2.2.3 - Approved vs Proposed Ground Floor Elevation - Vine Lane (West)

2.2.4 - Approved vs Proposed Ground Floor Elevation - High Holborn (South)

3.1.1 - Approved vs Proposed Servicing Strategy Summary

5.1.1 - Museum Street Elevation (East) - Approved vs Proposed

4.1.2 - Basement Level 2 Layout Summary

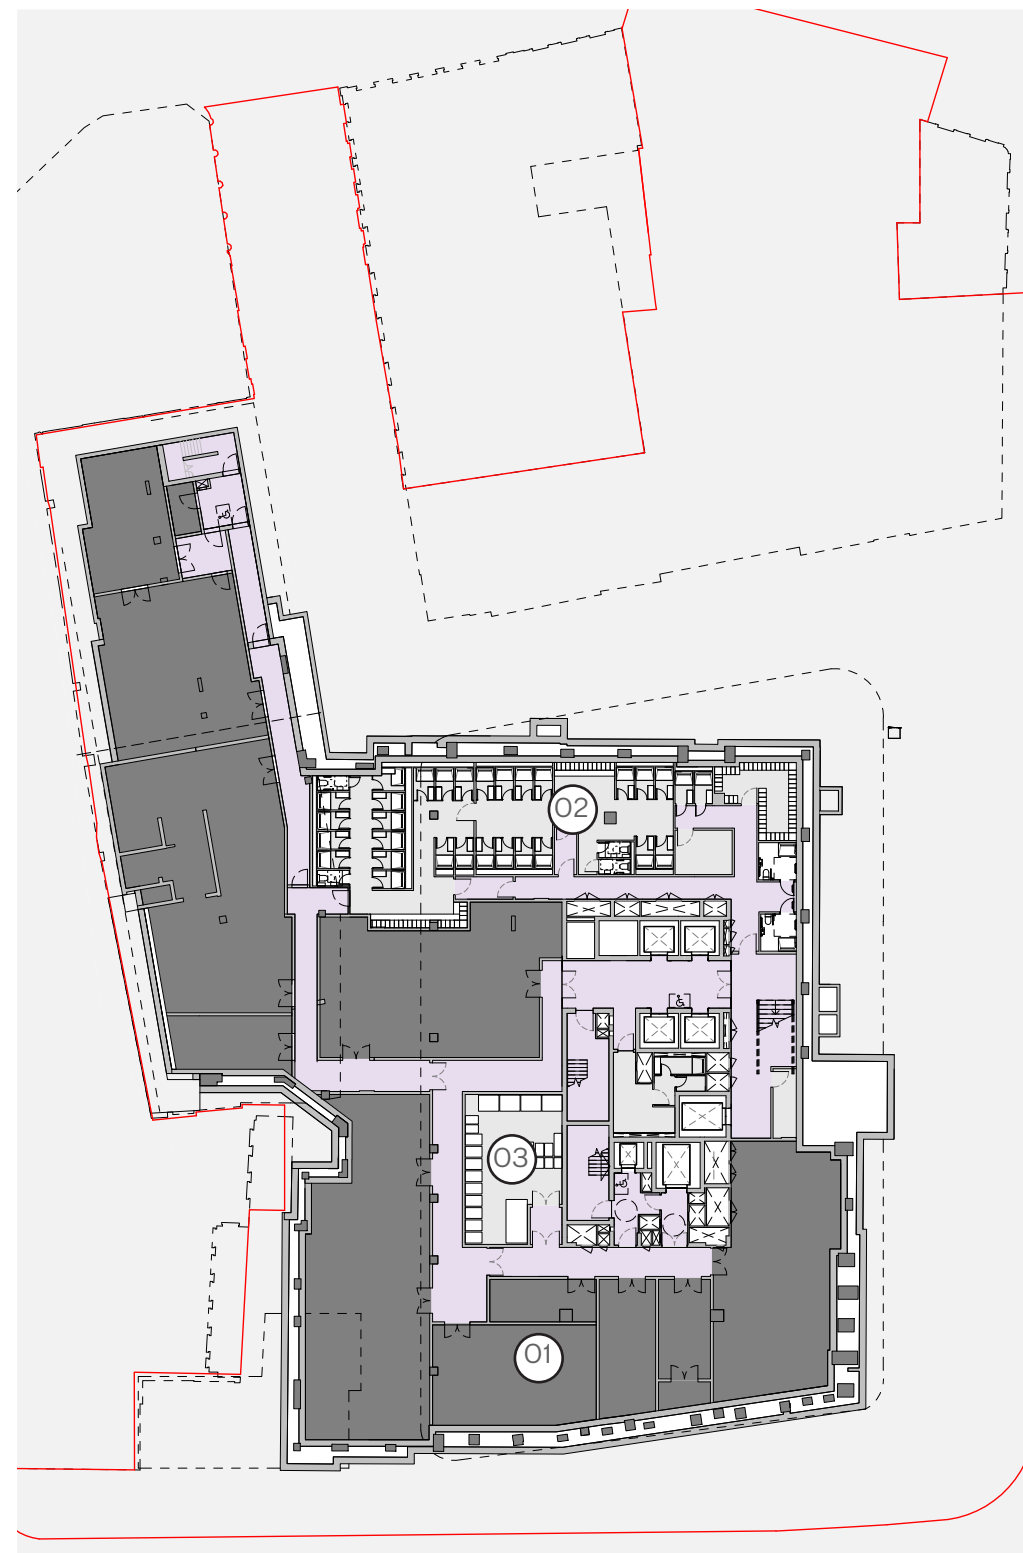
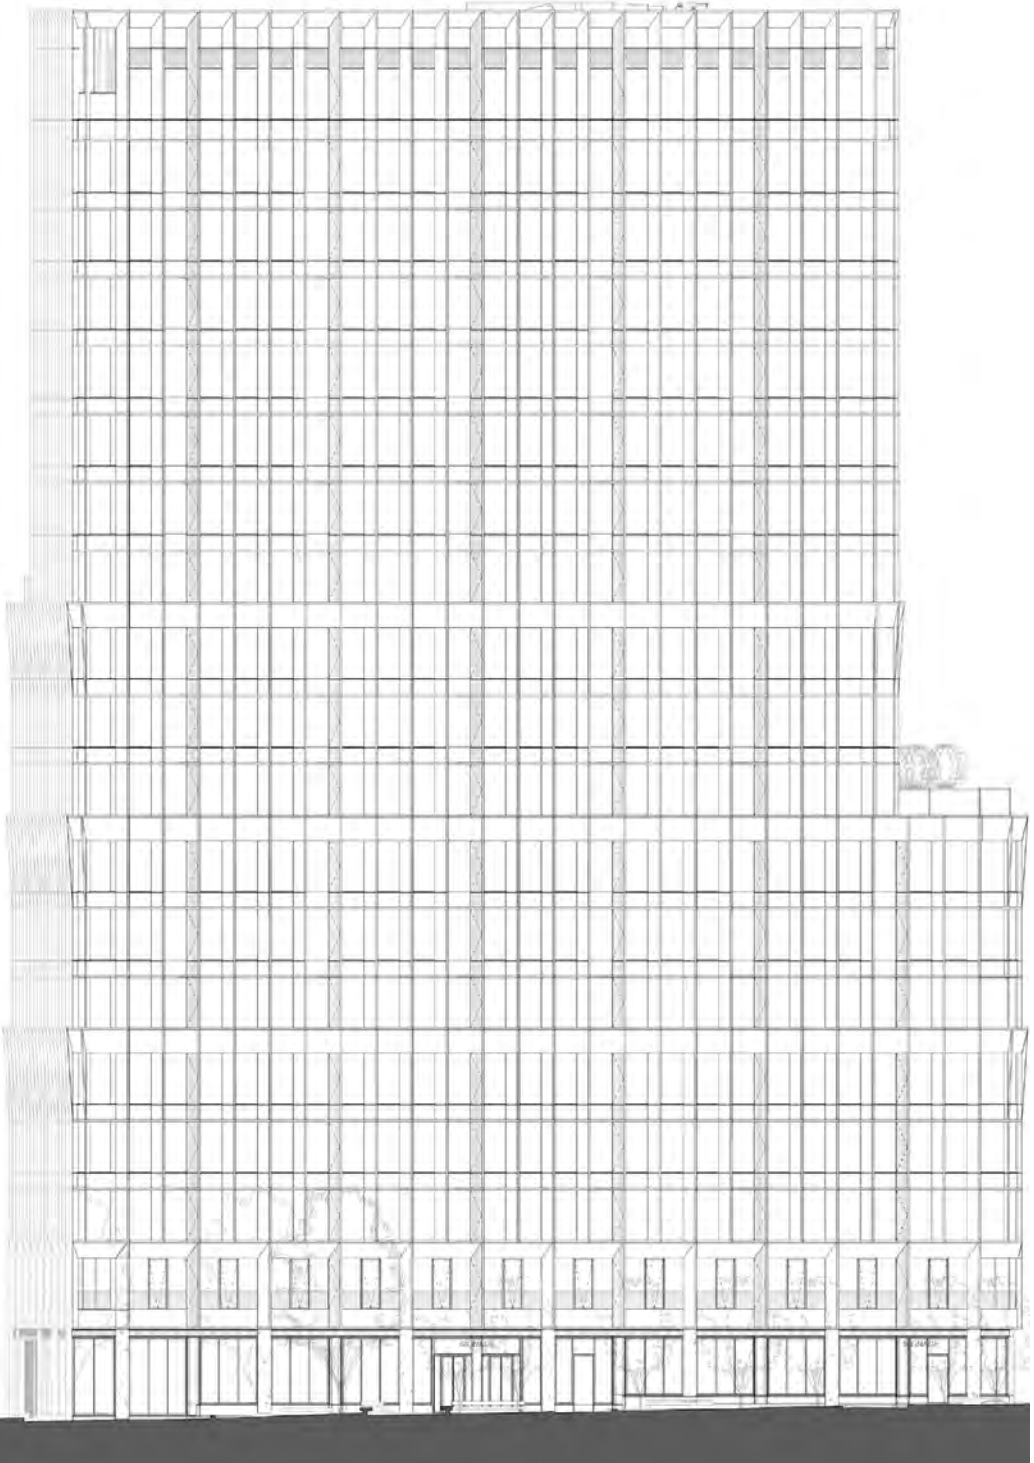
O1. The loading bay and vehicular lift have been removed at both basement levels - as part of the development of a more efficient servicing strategy for the building.

O2. Minor adjustments to the long stay cycle parking and shower facilities, capacity is in line with updated area schedule and compliant with London Plan requirements.

O3. The refuse store has been relocated to the west of building core.

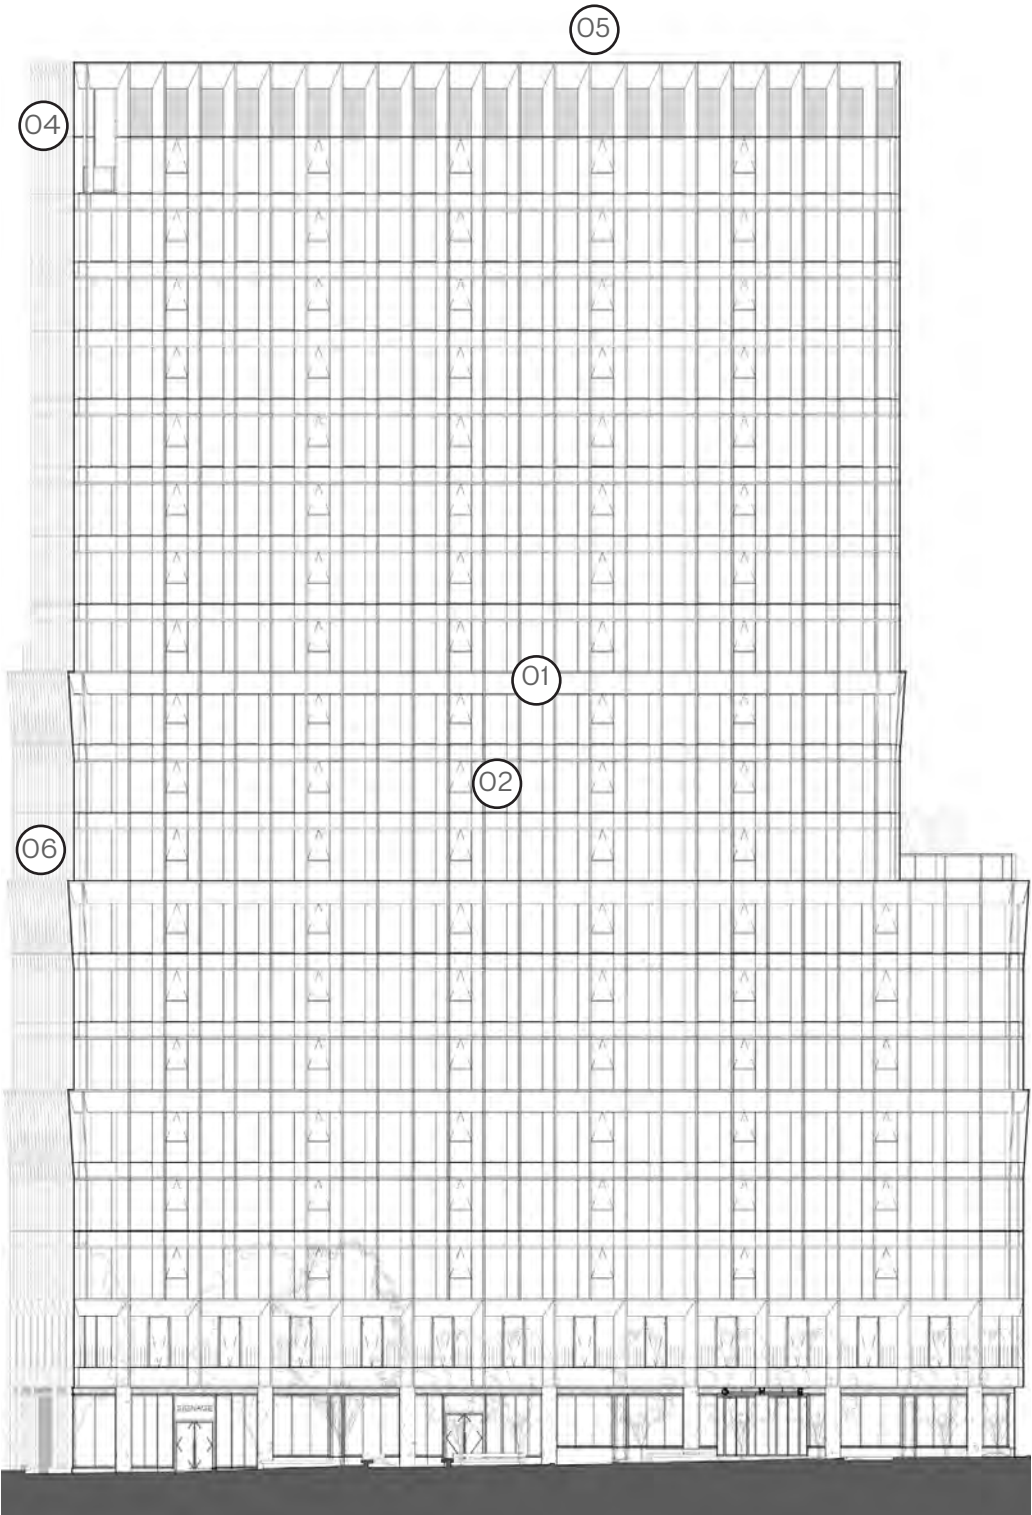
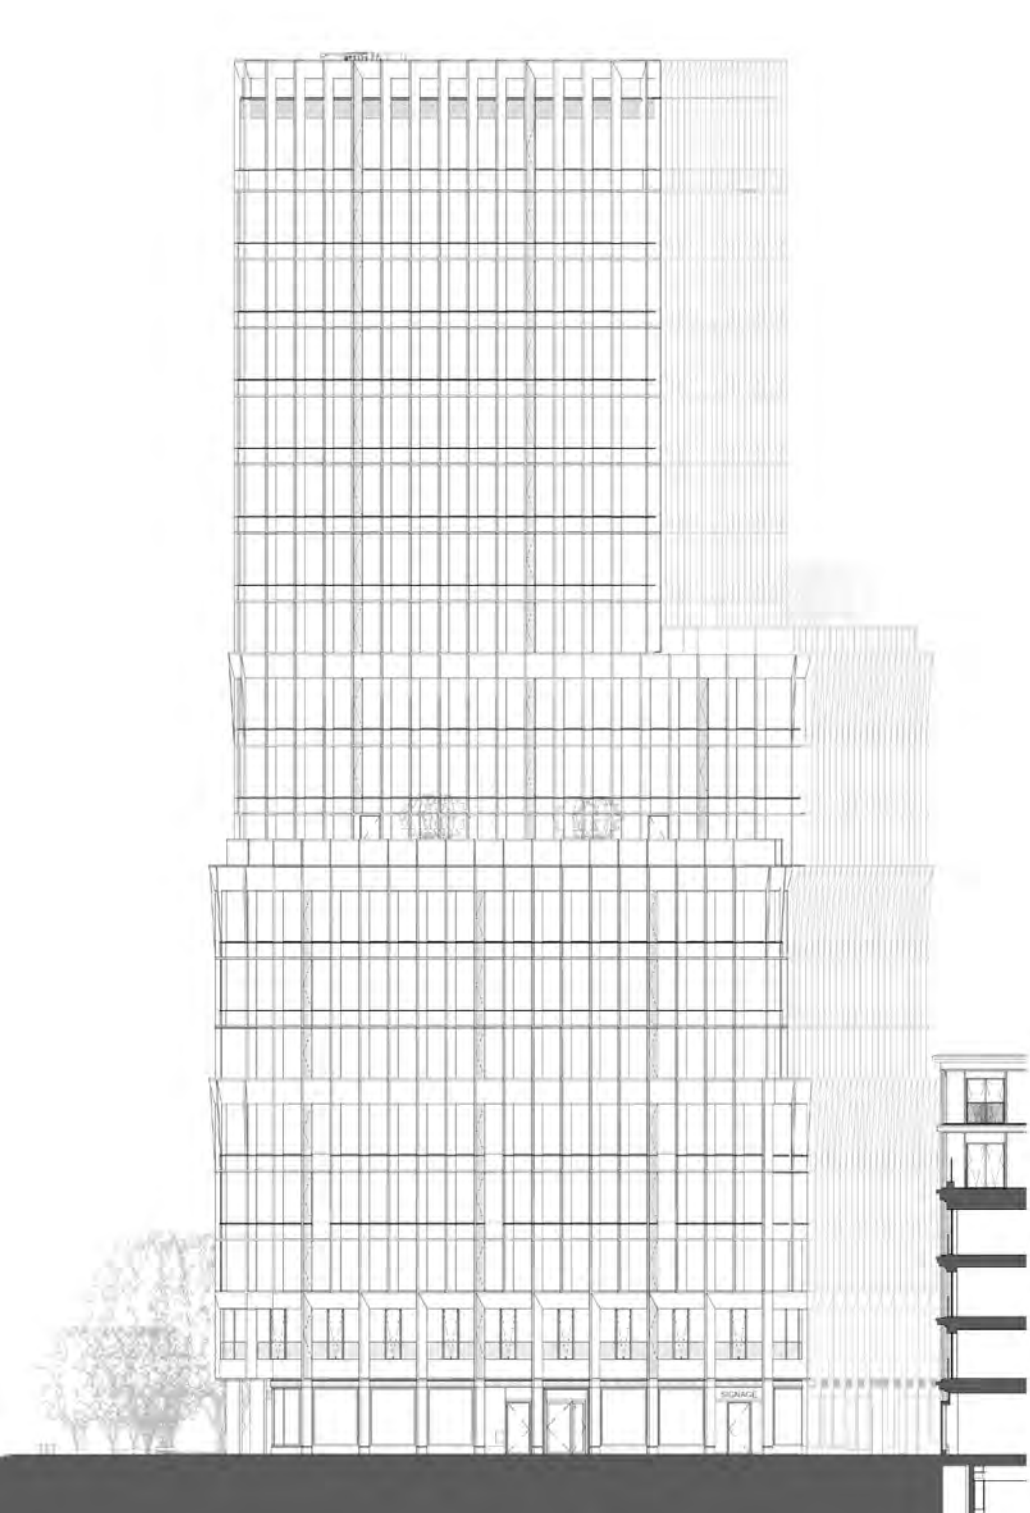
- 01. The facade design principles of the approved scheme remain the same with no change to materiality or tone. Note: Please refer to planning elevation drawings for facade materiality notes.

- 02. Operable panels across all facades have been replaced with openable windows within the glazed area to improve overall building thermal performance and futureproof flexibility.

- 03. Inset terraces introduced along the south elevation on Levels 7, 10, and 15.
- 04. Level 18 top floor south terrace size increased.
- 05. Building crown (top floor and building parapet) adjusted to accommodate changes to floor levels to incorporate additional plant at roof level. Building parapet height remains unchanged. Facade has been elongated and incorporates mirrored glazing.

- 06. Floor levels have been slightly adjusted, the overall height and massing remains unchanged - refer to pages 31-32 for a summary on levels adjustments.

- 07. Reduced internal facade depth by 100mm as a result of overall facade performance improvements.

5.1.2 - West Central Street Elevation (North) - Approved vs Proposed

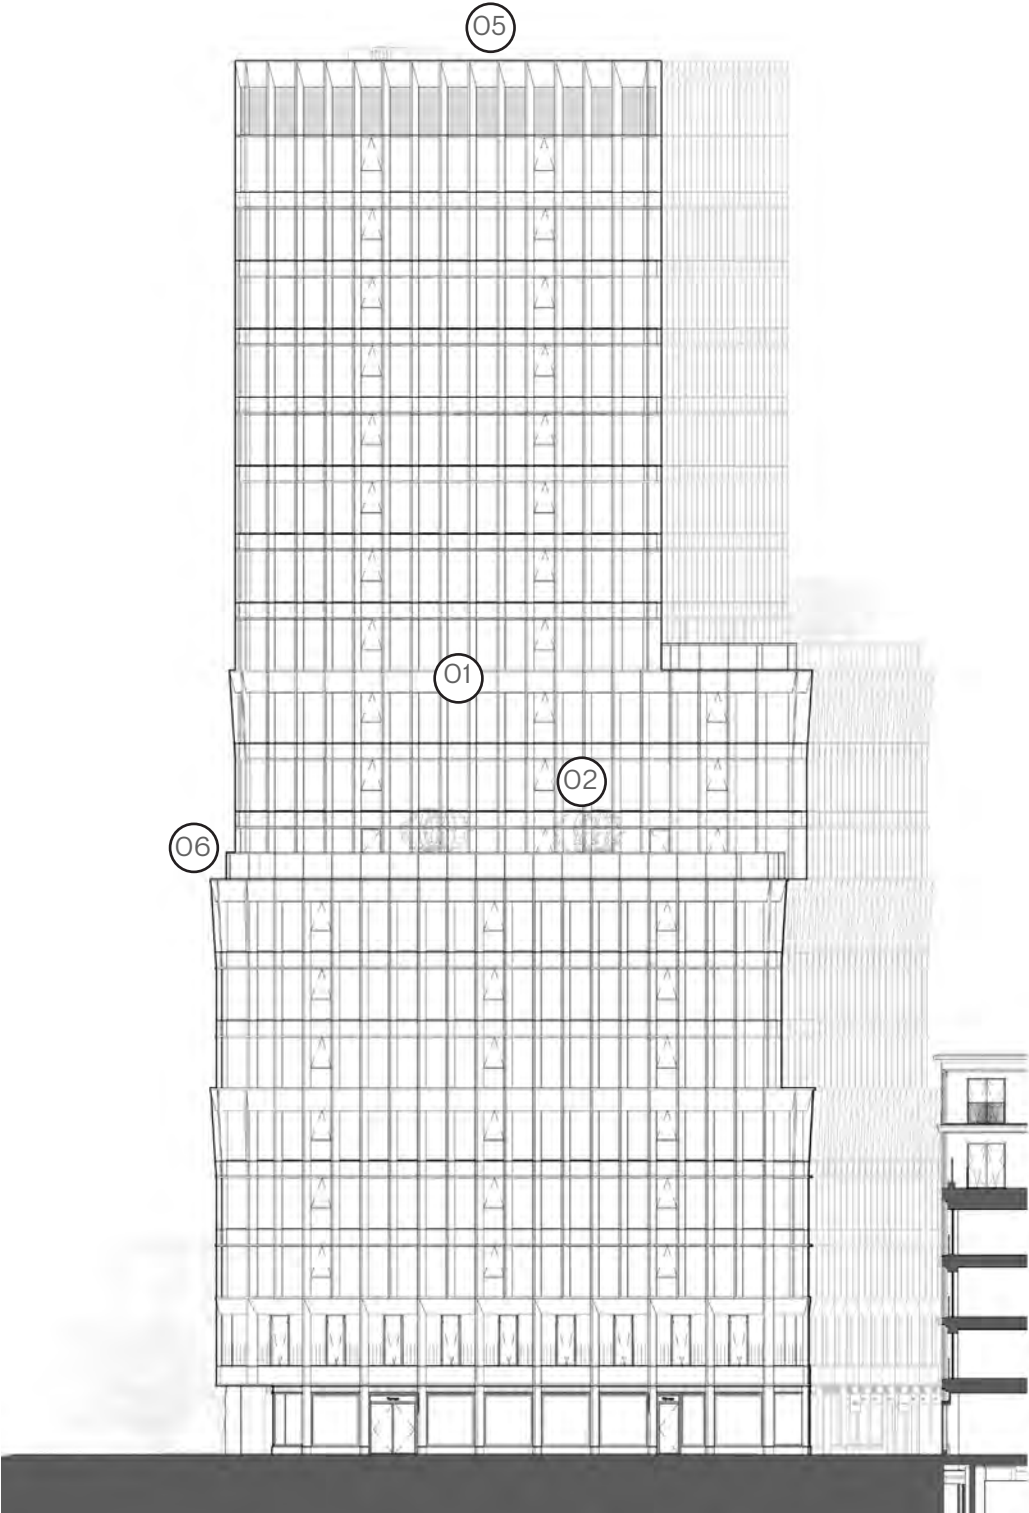
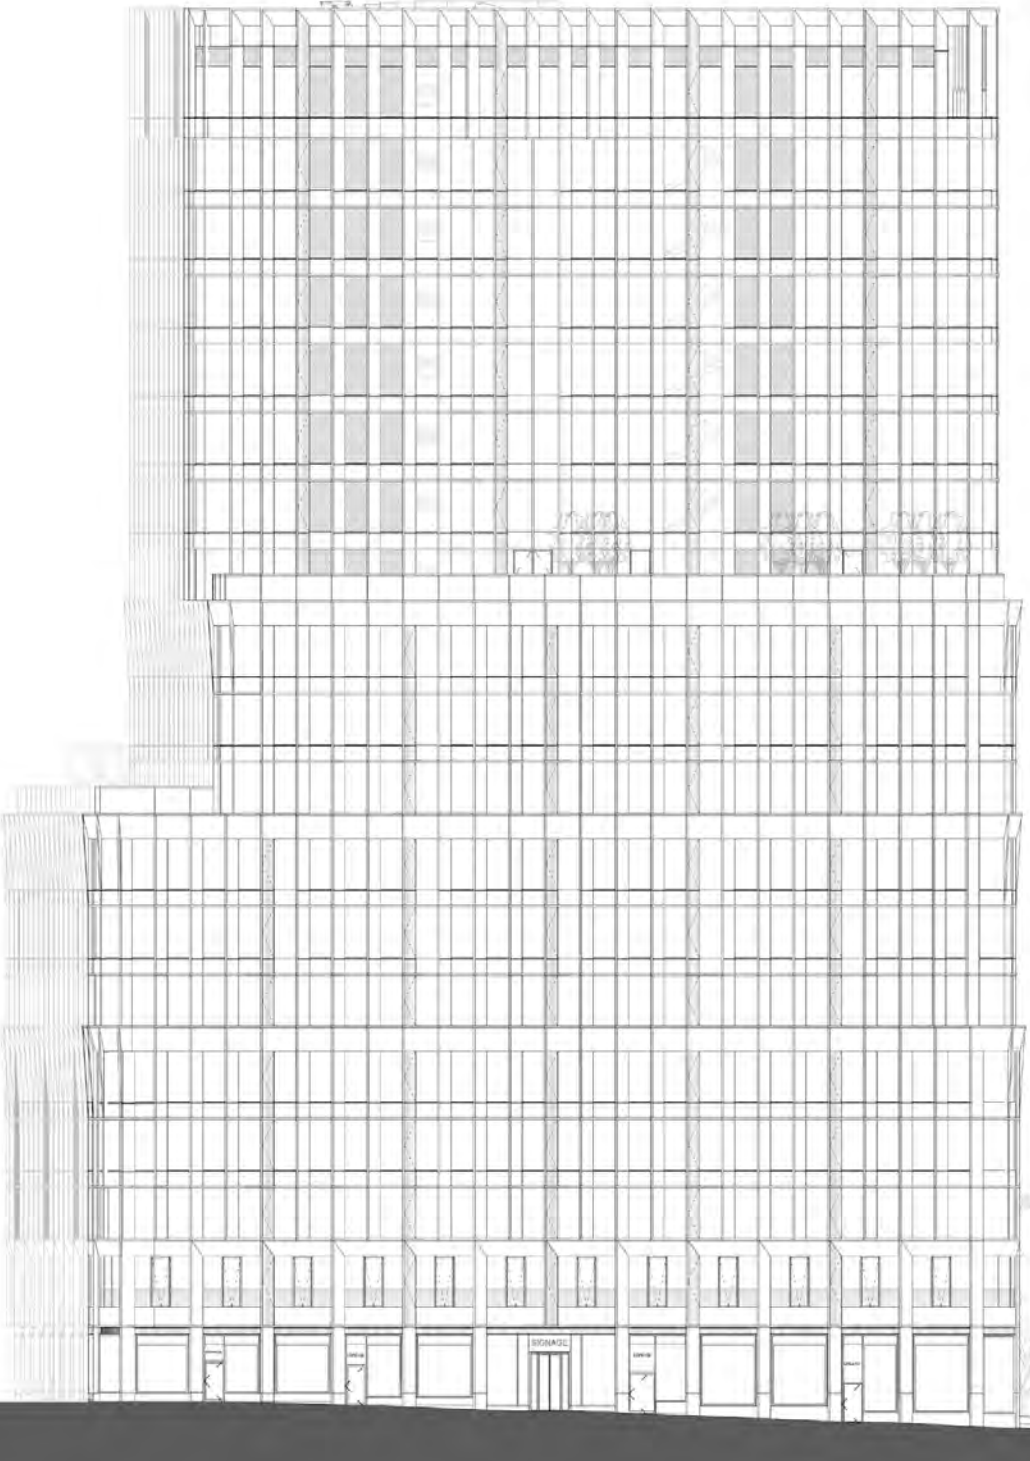
- O1. The facade design principles of the approved scheme remain the same with no change to materiality or tone. Note: Please refer to planning elevation drawings for facade materiality notes.

- O2. Operable panels across all facades have been replaced with openable windows within the glazed area to improve overall building thermal performance and futureproof flexibility.

- O3. Inset terraces introduced along the south elevation on Levels 7, 10, and 15.
- O4. Level 18 top floor south terrace size increased.
- O5. Building crown (top floor and building parapet) adjusted to accommodate changes to floor levels to incorporate additional plant at roof level. Building parapet height remains unchanged. Facade has been elongated and incorporates mirrored glazing.

- O6. Floor levels have been slightly adjusted, the overall height and massing remains unchanged - refer to pages 31-32 for a summary on levels adjustments.

- O7. Reduced internal facade depth by 100mm as a result of overall facade performance improvements.
- O8. Increased glazing ratio to the north facade of the proposed scheme. The approved scheme has a glazing ratio of circa. 46%, while the proposed S73 scheme has glazing ratio of circa. 51% (a 5% increase) which will improve daylighting to the office floors.
